DUKE POWER COMPANY  
OCONEE NUCLEAR STATION  
ATTACHMENT 1a  
IMPROVED TECHNICAL SPECIFICATIONS

This proposed amendment revises the pressure-temperature limits of Improved Technical Specification (ITS) 3.4.1 and Current Technical Specification (CTS) 3.1.2 for Oconee Units 1, 2, and 3. The proposed amendment will revise the heatup, cooldown, and inservice test limitations for the reactor coolant system of each unit. For Units 1, 2, and 3, the current pressure-temperature limits are established to 21, 19, and 21 effective full power years (EFPY), respectively. The service period for the new pressure temperature limits will be to a maximum of 26 EFPY for Units 1, 2 and 3.

Figure 3.1.2-3B

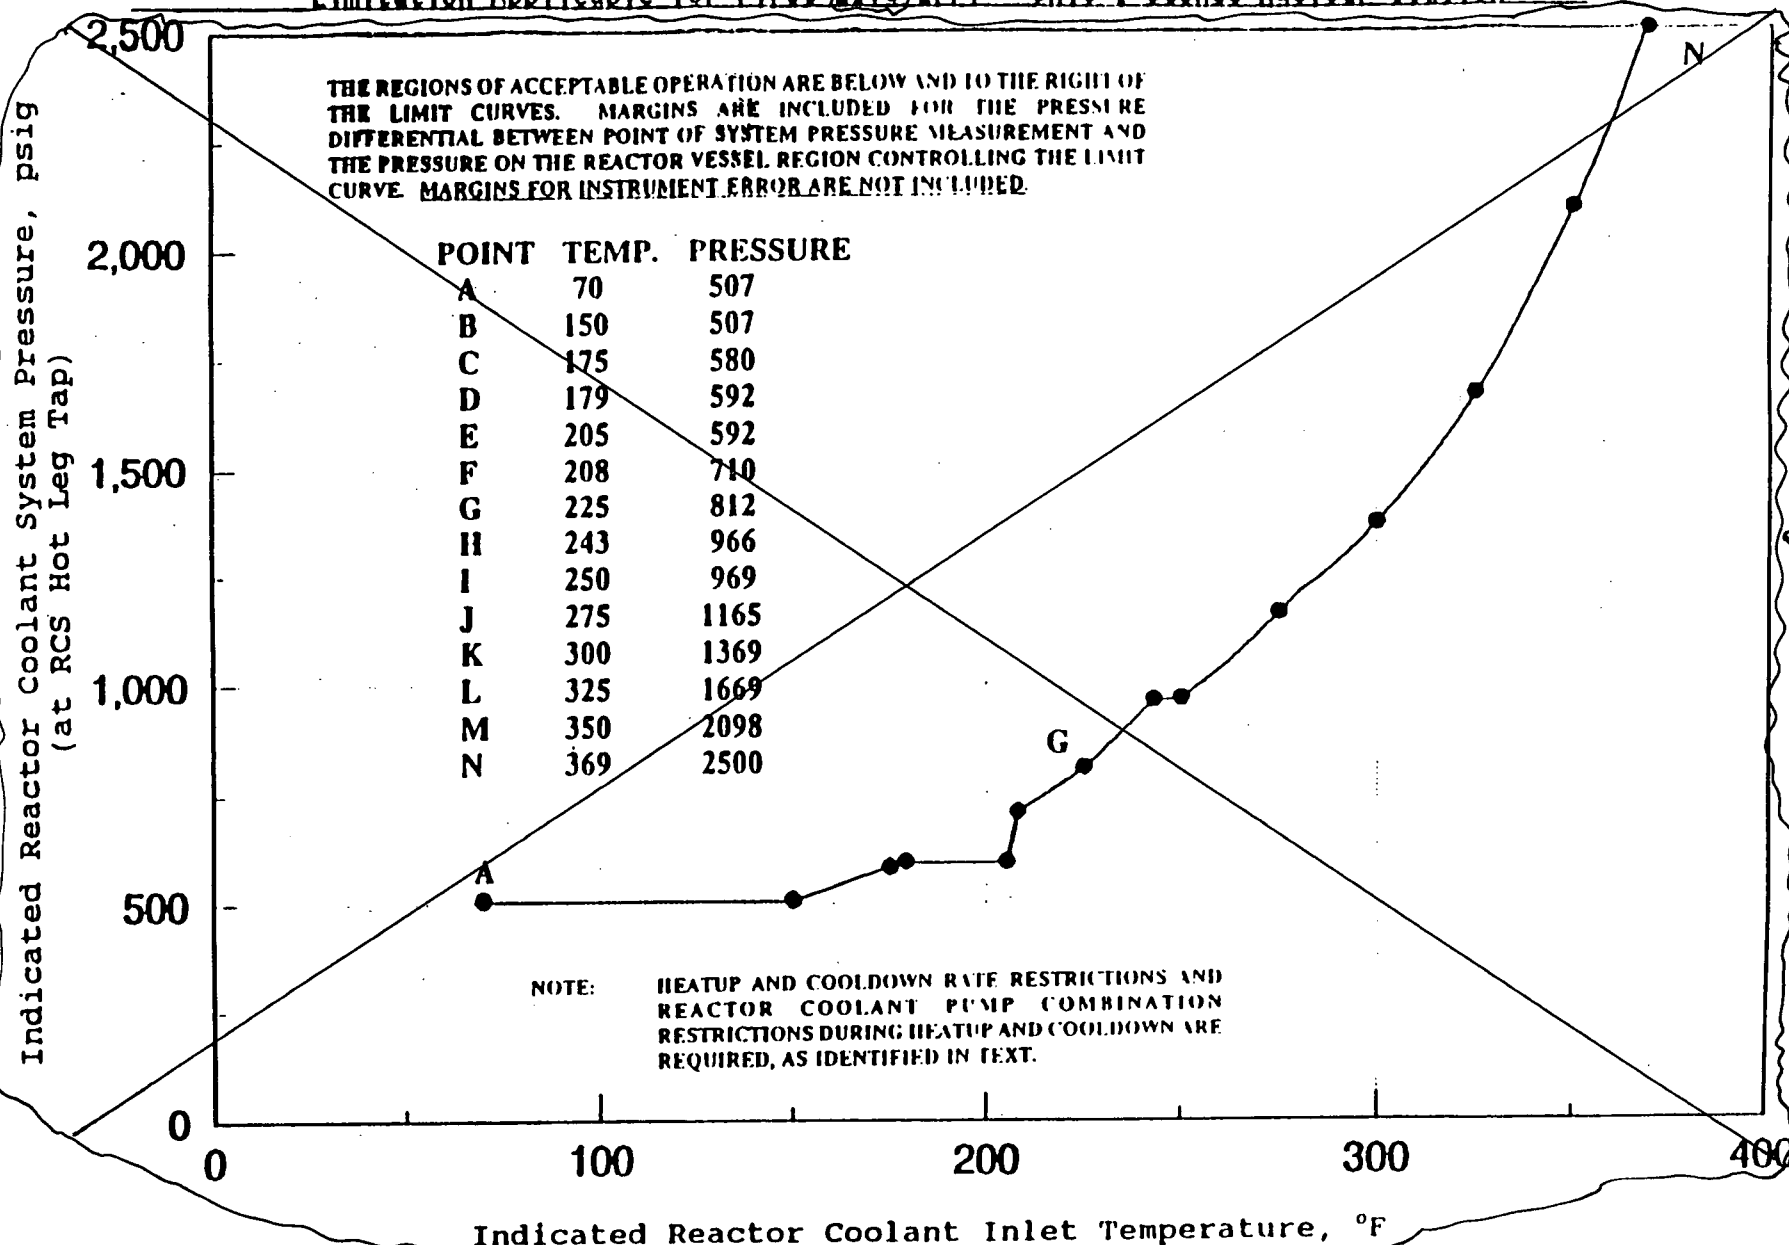
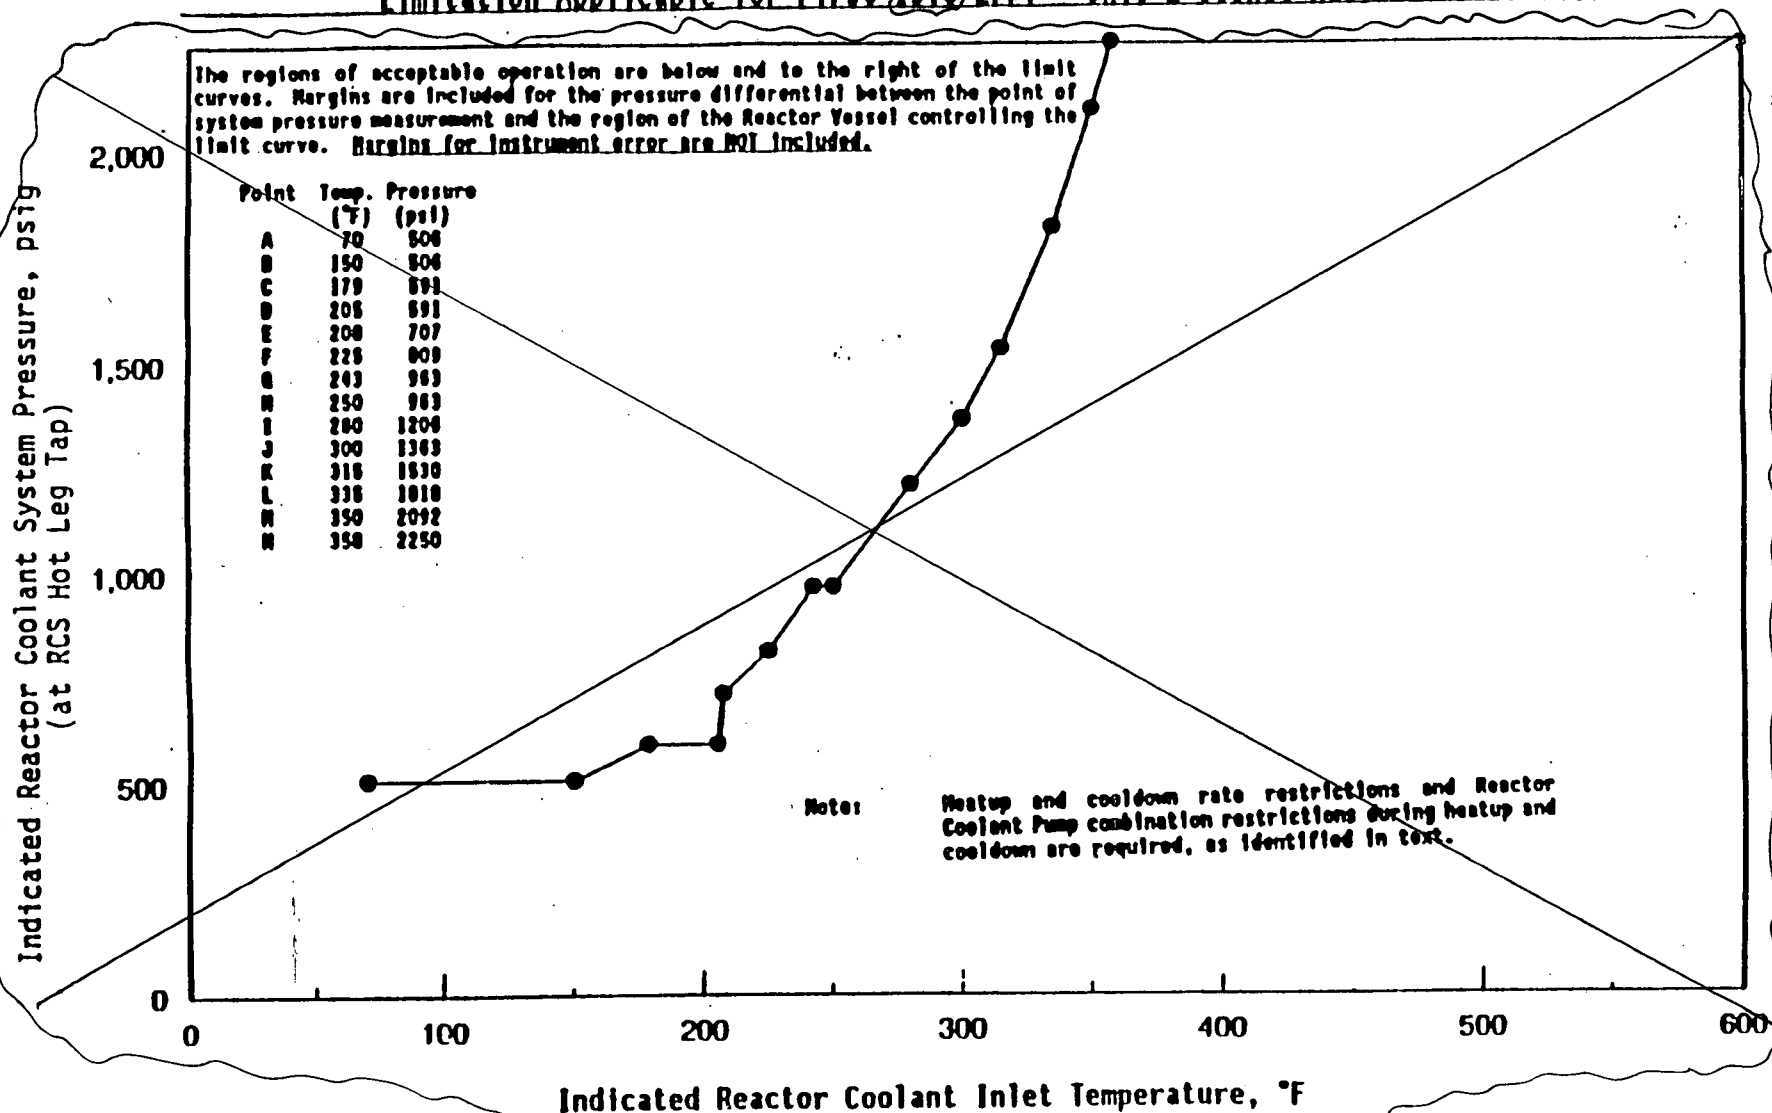
The proposed change also corrects an error in CTS Figure 3.1.2-3B, concerning the maximum test pressure for the Unit 2 inservice leak and hydrostatic test heatup and cooldown limits. Due to an oversight, the curve produced by Babcock and Wilcox (B&W) which became the CTS Figure 3.1.2-3B, indicated an upper pressure temperature limit of 2250 psig when it should have provided a pressure temperature limit of 2500 psig. The upper pressure temperature limit had been at 2500 psig prior to approval of the current pressure-temperature limits by the NRC on January 25, 1994. This correction also applies to ITS curve, ITS Figure 3.4.3-6. During the effective period of CTS Figure 3.1.2-3B, Unit 2 Reactor Coolant System pressure has not exceeded 2250 psig.
